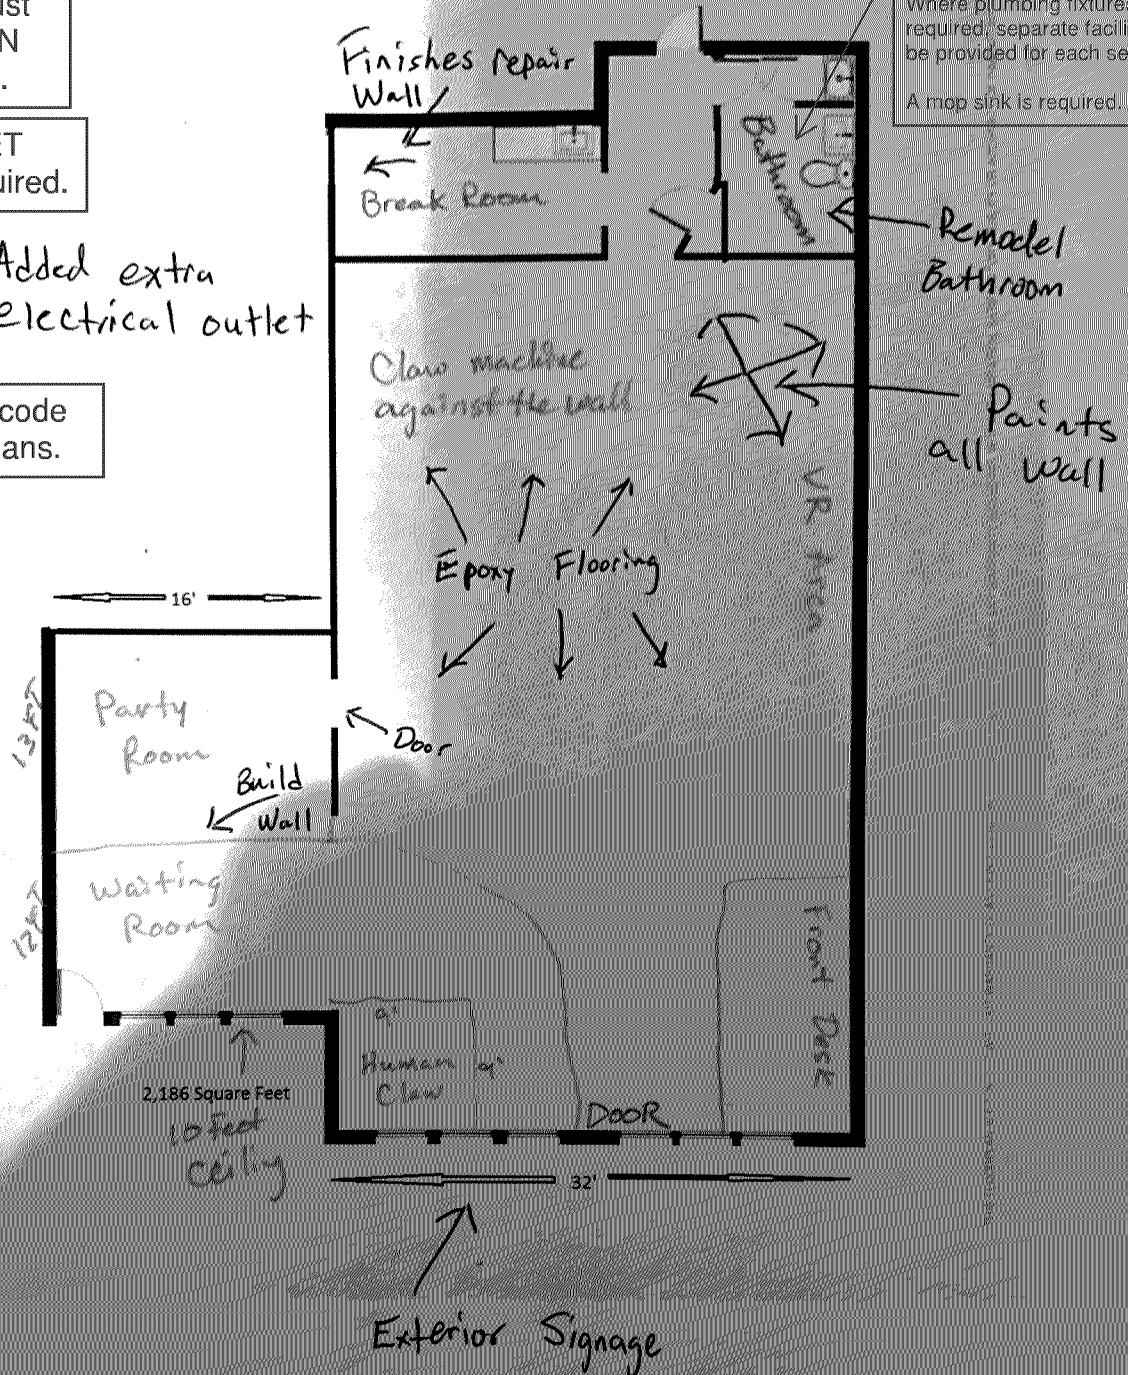
Entire space(s) shall have fully Code complying sprinkler protection.

Building/property shall be adequately signed for emergency response.

The sprinkler system may need to be upgraded in the space depending on the amount of additional plastics/combustible material.

Must meet 2020 MN
State Building Code

Must meet 2020 MN
Accessibility Code.

Building plans must
be signed by a MN
licensed architect.

SAC review by MET
council will be required.

Plumbing fixture count shall
meet requirements of Table
2902.1 of 2020 MN Building
Code. Based on number of
occupants at least 2 restrooms
may be required.

Where plumbing fixtures are
required, separate facilities shall
be provided for each sex.

A mop sink is required.

* Added extra
electrical outlet

Provide a detailed code
analysis with the plans.
